**PB# 01-51**

**Fox Meadow Estates**

**TOWN OF NEW WINDSOR**  
**PLANNING BOARD**  
**REVIEW COMMENTS**

**PROJECT NAME:** FOX MEADOW ESTATES MAJOR SUBDIVISION  
**PROJECT LOCATION:** TOLEMAN ROAD  
SECTION 52 – BLOCK 1 – LOT 20  
**PROJECT NUMBER:** 01-51  
**DATE:** 24 MARCH 2004  
**DESCRIPTION:** THE APPLICATION PROPOSES THE MAJOR SUBDIVISION OF THE 82.4 +/- ACRE PARCEL, WITH A HORSE FARM TO REMAIN. THE PLAN WAS PREVIOUSLY REVIEWED AT THE 8 AUGUST 2001, 14 NOVEMBER 2002, 23 JANUARY 2002, 26 JUNE 2002, 28 AUGUST 2002 AND 23 OCTOBER 2002 PLANNING BOARD MEETINGS.

**STANDARD SIDEWALK DETAIL**  
NOT TO SCALE

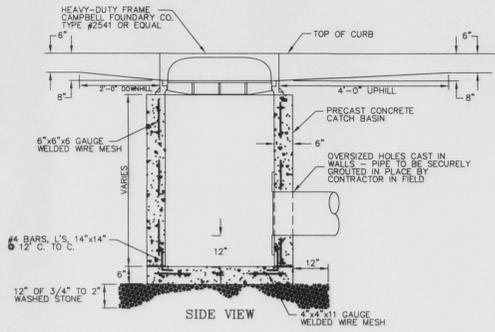
- Correct roadway detail to note 4000 psi concrete (minimum) for the curb and sidewalk.
  - Submit the Public Improvement Bond Estimate to the Town for review, and subsequent approval of the Town Board.
